#### **Addendum 47 – UN Regulation No. 48**

#### **Revision 12 - Amendment 8**

Supplement 12 to 06 series of amendments – Date of entry into force: 15 October 2019

#### **Installation of lighting and light-signalling devices**

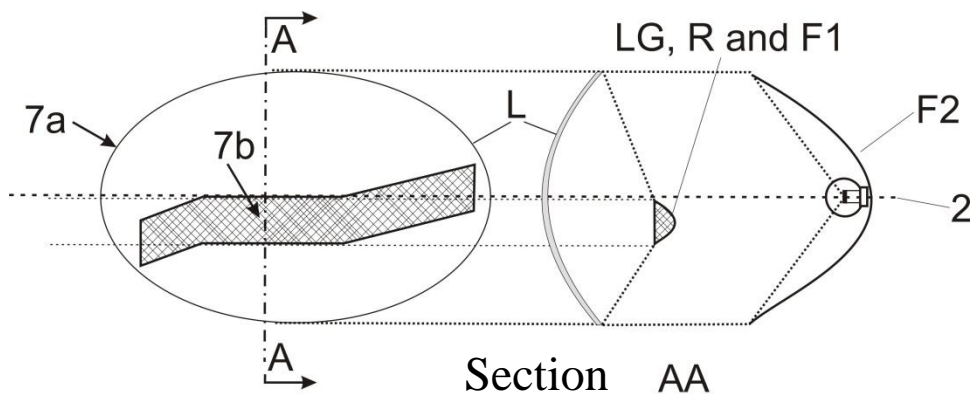
Part 5, amend to read:

"Part 5 – Example of illuminating surface in comparison with light-emitting surface in the case of a "single function lamp" (see paragraphs 2.10.2. to 2.10.3. of this Regulation)

In the case where the non-textured outer lens is excluded, "7b" is the apparent surface according to paragraph 2.10.2. (b).

Example of a light guide optic or a reflector optic behind an outer lens:

Example 8

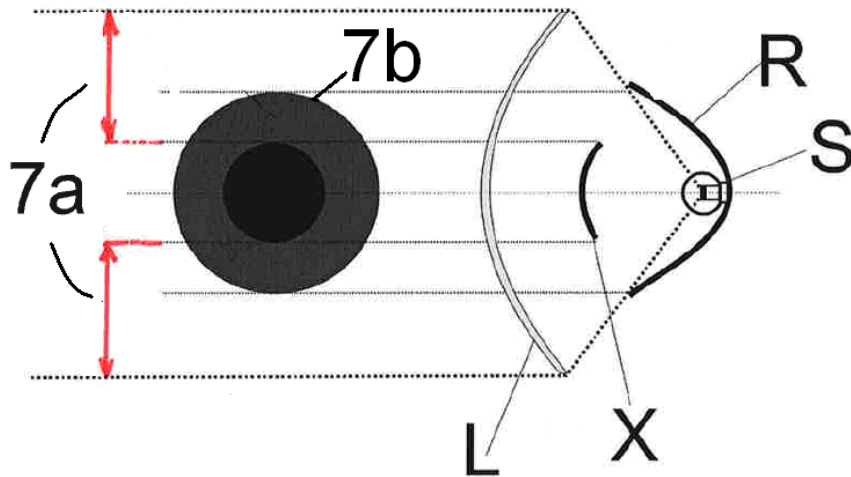
In the case where the non textured outer lens is excluded, "7b" is the apparent surface according to paragraph 2.10.2. (b), and F1 shall not transparent to F2

Example of a light source with a reflector optic in combination with an area which is not part of this function, behind an outer lens:

Example 9

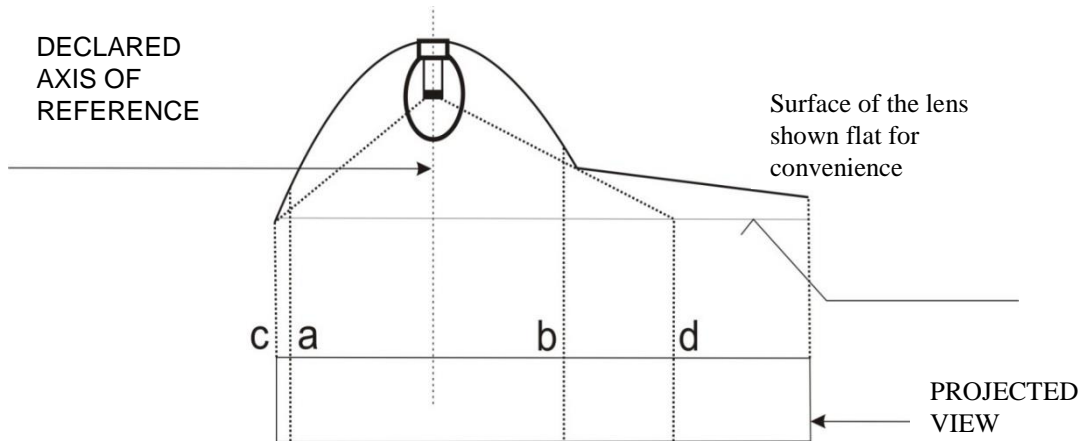
In the case where the non textured outer lens is excluded, "7b" is the apparent surface according to paragraph 2.10.2. (b).

Example A

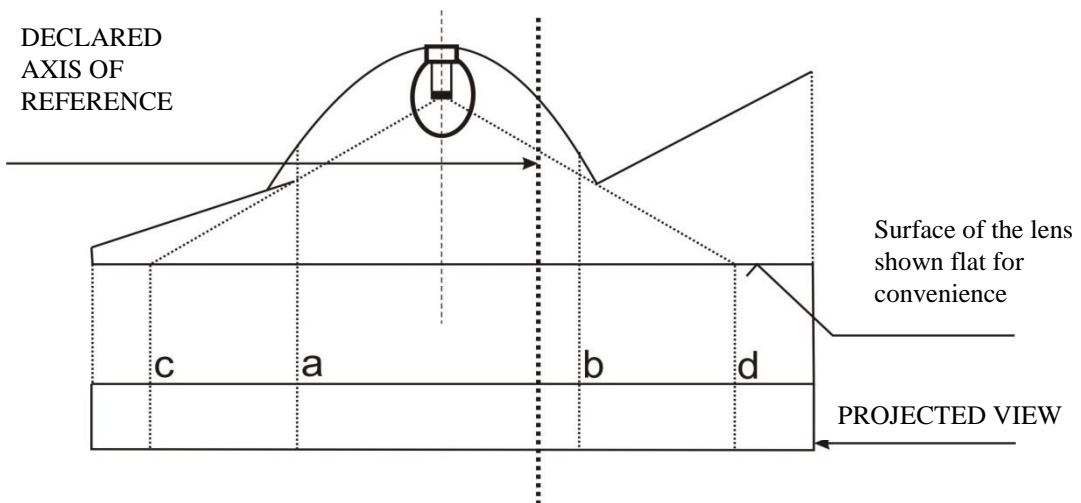
Part 6, amend to read:

<i>Illuminating surface</i>	<i>Declared light-emitting surface according to 2.10.2. (a)</i>
Edges are	a and b	c and d

Example D

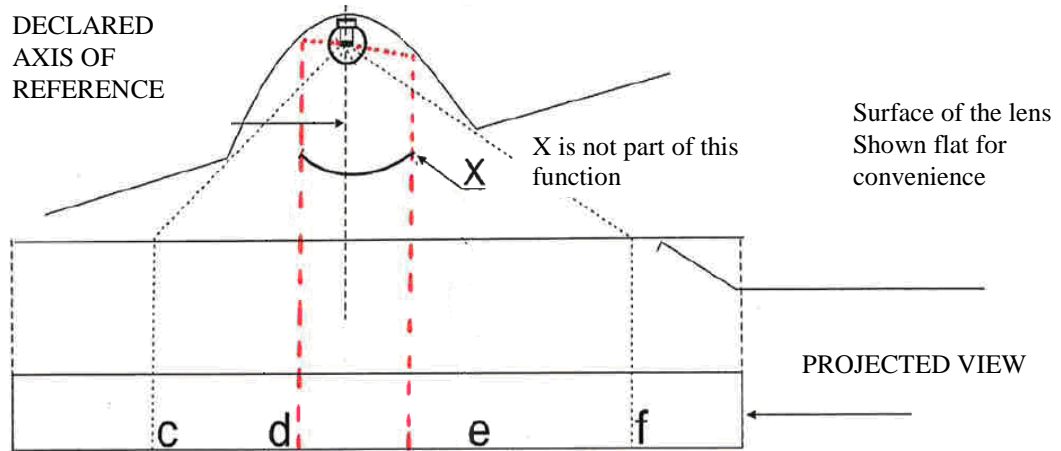
Example to determine a light emitting surface according to 2.10.2. (a) in combination with an area which is not part of the function:

<i>Declared Light-emitting surface according to 2.10.2. (a)</i>
Edges are	c-d and e-f

Example E

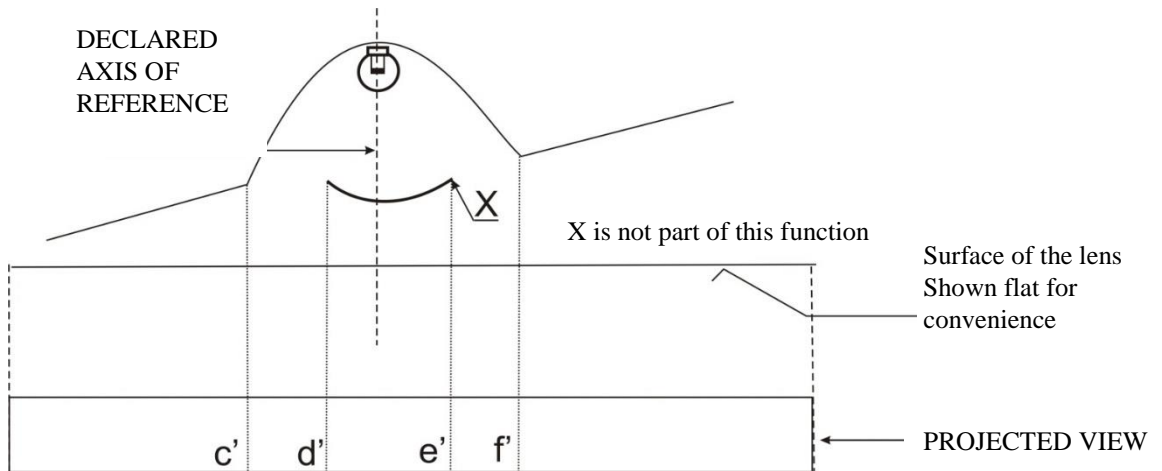
Example to determine the apparent surface in combination with an area which is not part of the function and a non-textured outer lens (according to 2.10.2. (b)):

<i>Declared Light emitting surface according to 2.10.2. (b) for example</i>
Edges are	c'-d' and e'-f'

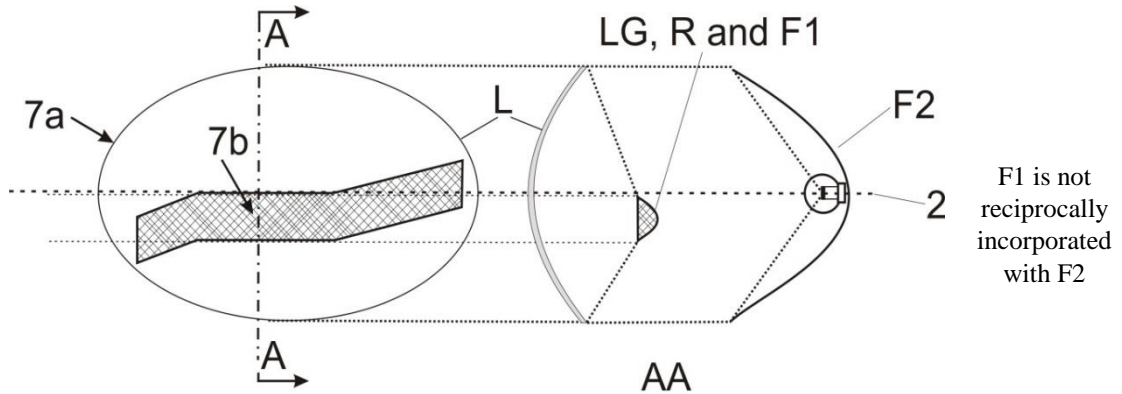
Part 7, amend to read:

In the case where the non-textured outer lens is excluded, "7b" is the apparent surface according to paragraph 2.10.2. and F1 shall not be transparent to F2:

**Gonio(photo)meter system used for the photometric measurements as defined in paragraph 2.10.9. of this Regulation**

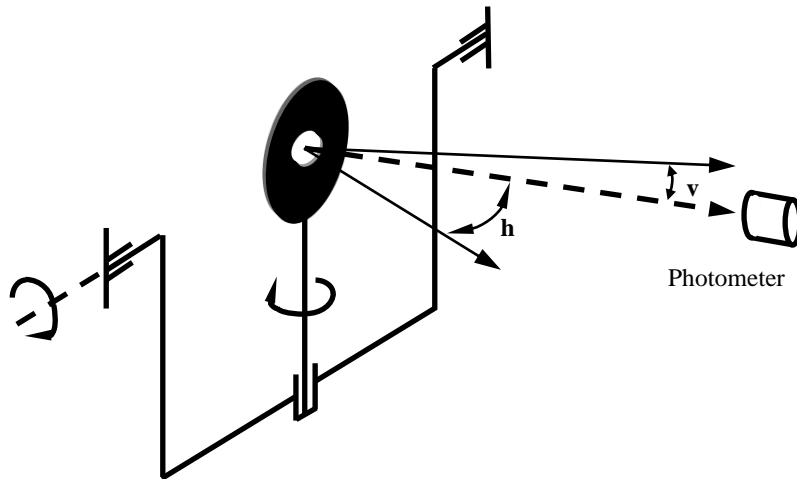
Annex 15, amend to read:
